**STAFF REPORT  
KETCHUM PLANNING AND ZONING COMMISSION  
REGULAR MEETING OF JULY 11, 2023**

**PROJECT:** Pratt Residence

**FILE NUMBER:** P23-009 and P23-009A

**APPLICATION TYPE:** Mountain Overlay Design Review and Conditional Use Permit

Figure 3: Site Survey

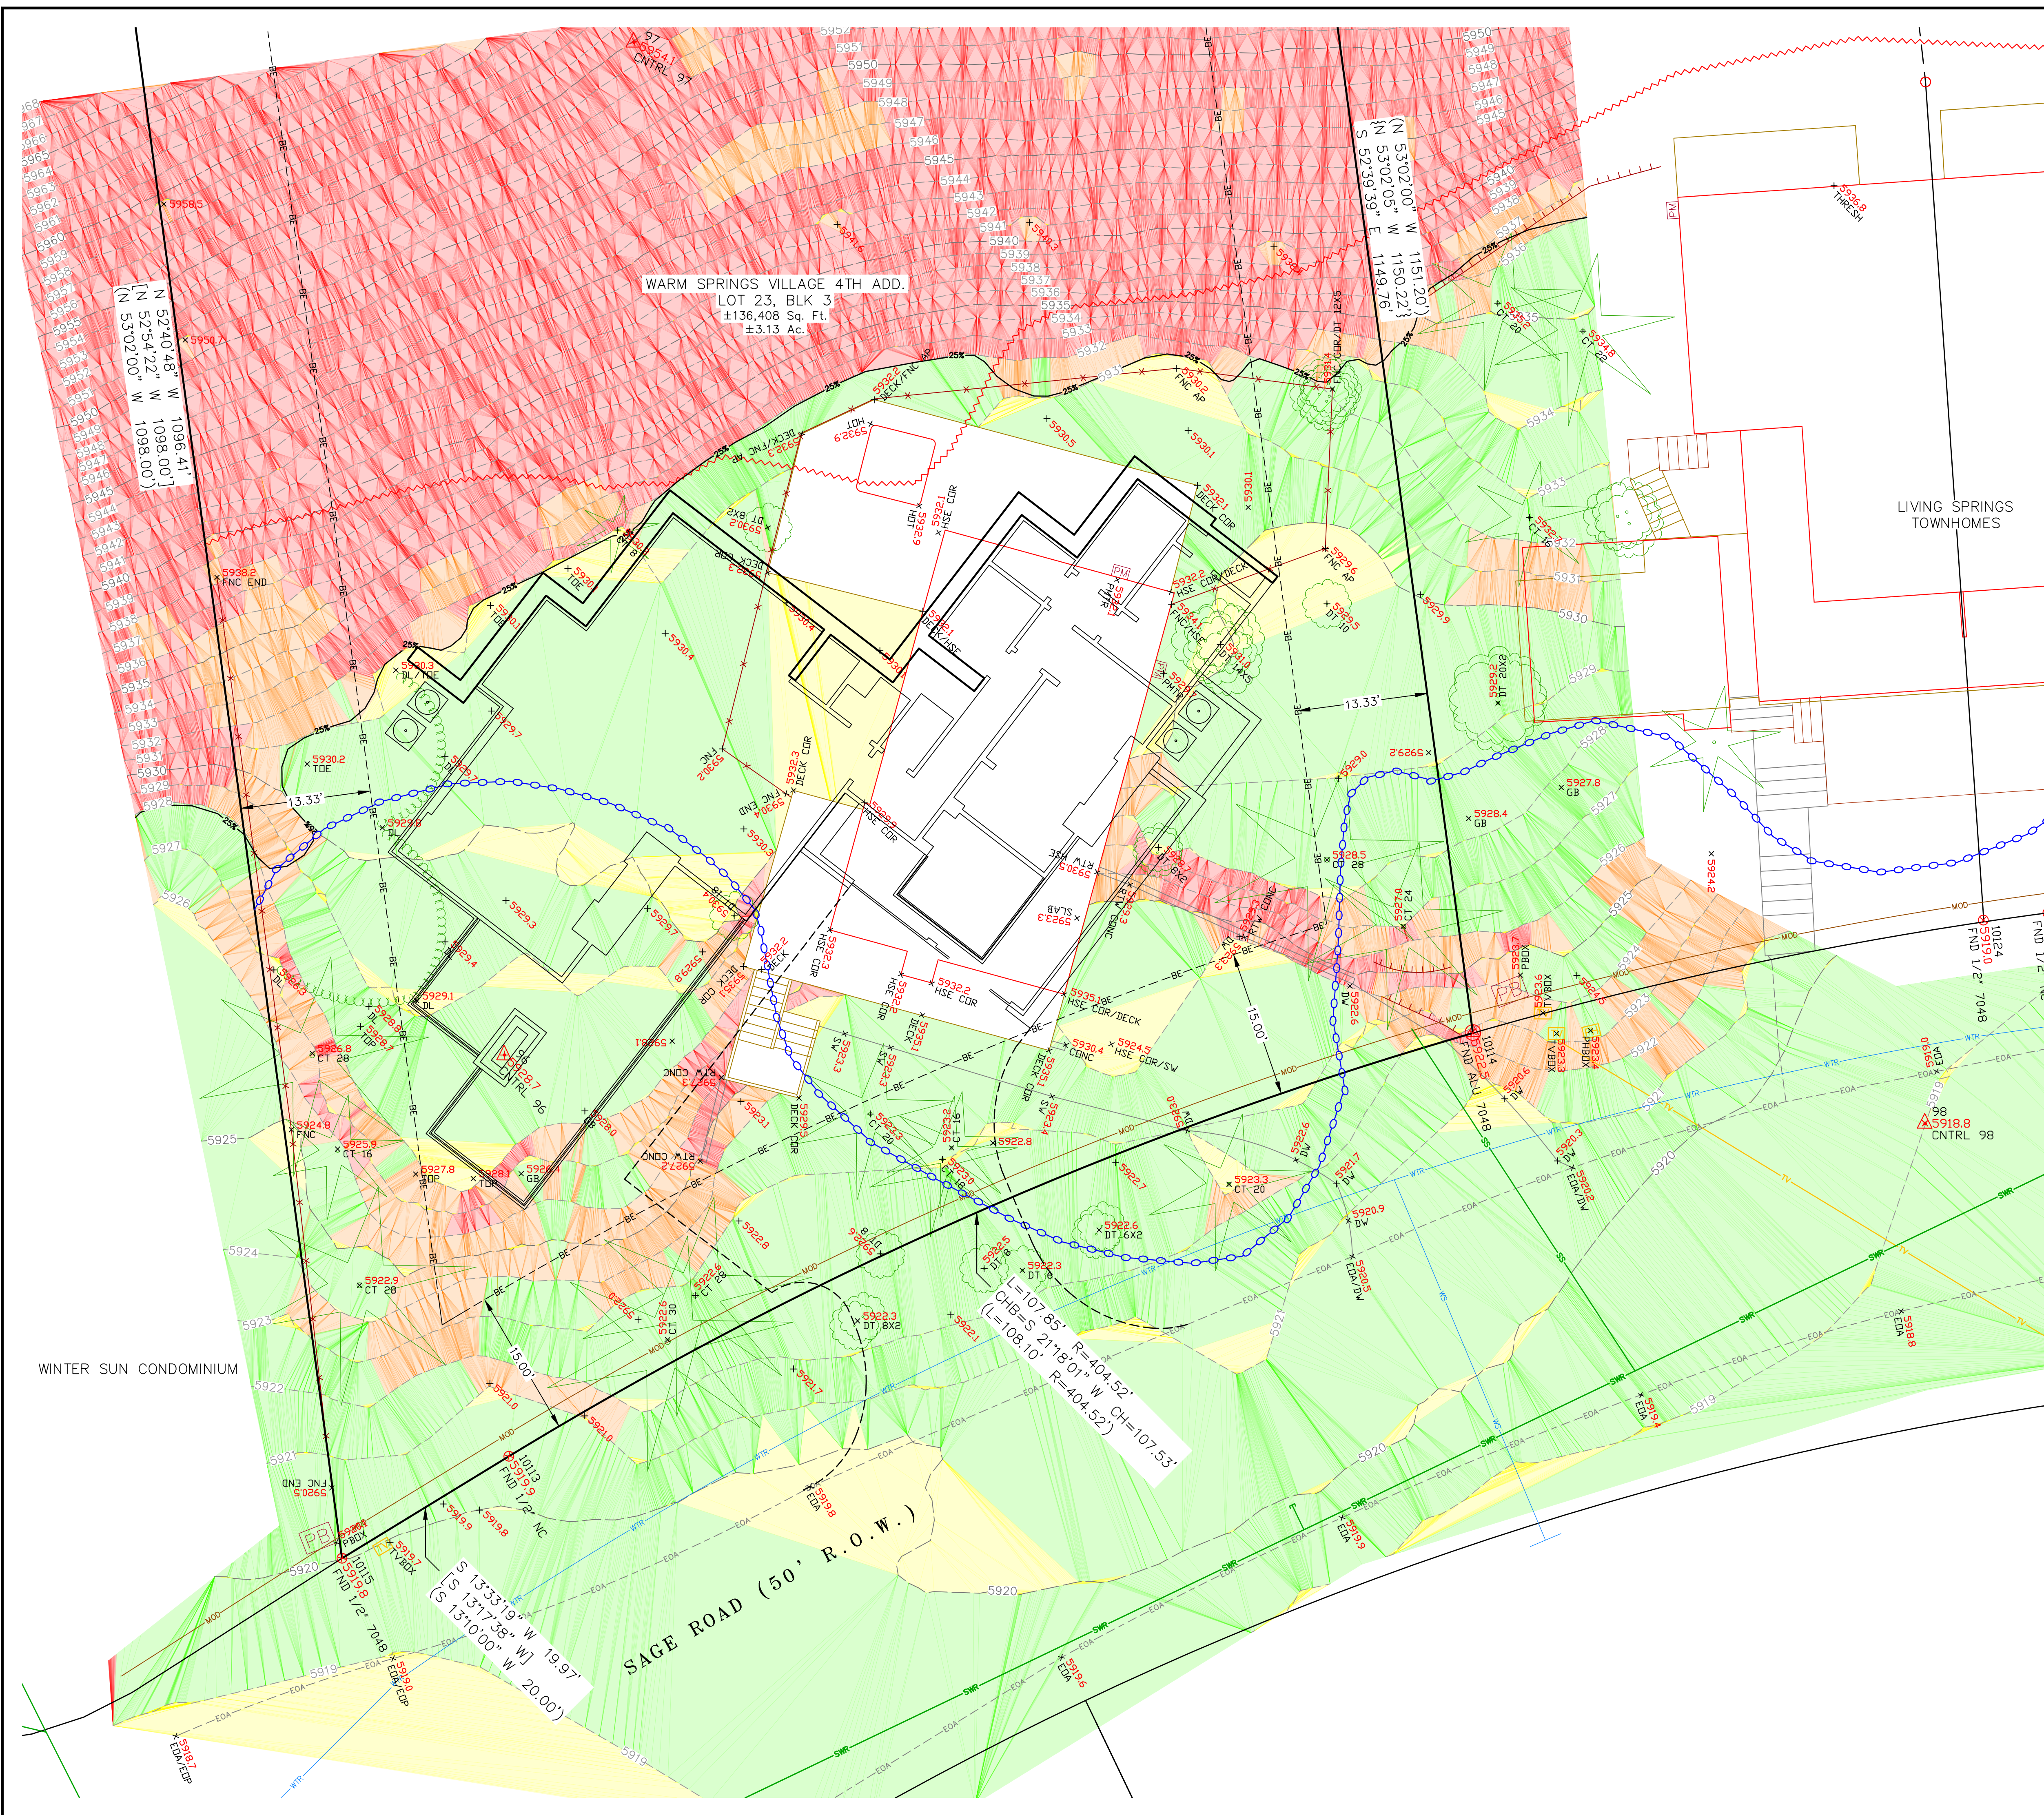
Currently, the existing nonconforming single-family residence on the property is located outside of the 25% slope. However, due to the grading lines on the site survey (Figure 3), it appears that the entire lot was previously within 25% slope and was graded for the construction of the existing structure on the lot.
